Measuring RIN_{xx}OMA using an Oscilloscope

IEEE 802.3 Interim Meeting – 802.3dj D1.2 Comment Resolution
Hamburg, Germany

RIN_{xx}OMA - IEEE 802.3dj – Draft 1.1 - Clause 180.9.11

Measuring the Electrical Noise Power (P_N)

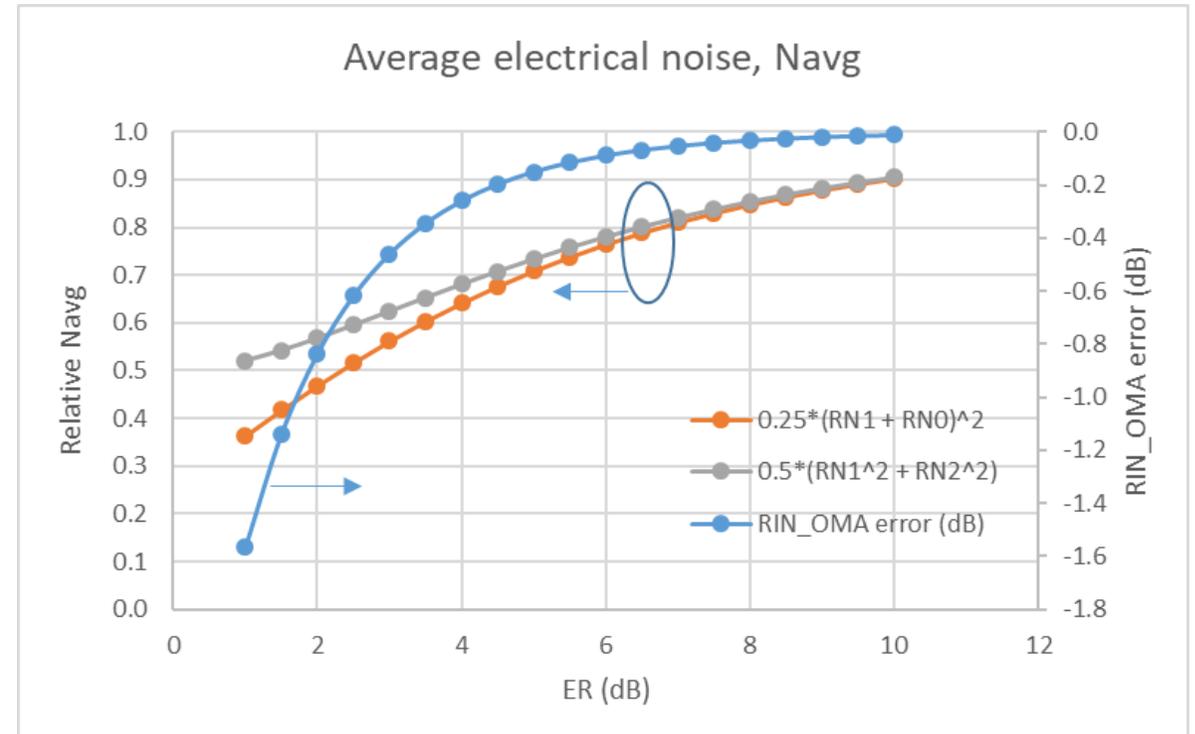
- The $RIN_{xx}OMA$ definition is dependent on the interpretation of the electrical noise power (P_N)
- Both definitions (averaging and RSS averaging RN_3 and RN_0) will lead to a very similar $RIN_{xx}OMA$ value at the OER range of IEEE 802.3dj (> 3.5dB)
- The current definition, using $(RN_3 + RN_0)/2$ to calculate the electrical noise power, is a closer match to the original definition of P_N in IEEE Std 802.3ae™ - 2002
- Using an RSS average is also an acceptable approach; however, it does not match the historic $RIN_{xx}OMA$ measurement used for many years now
- We recommend sticking to the current definition and dropping the /4 factor from the current draft
- Therefore; $RIN_{xx}OMA$ should be defined as:

$$RIN_{xx}OMA = 10 \log_{10} \frac{(RN_3 + RN_0)^2}{OMA_{outer}^2 \times BW_N} \text{ (dB/Hz)}$$
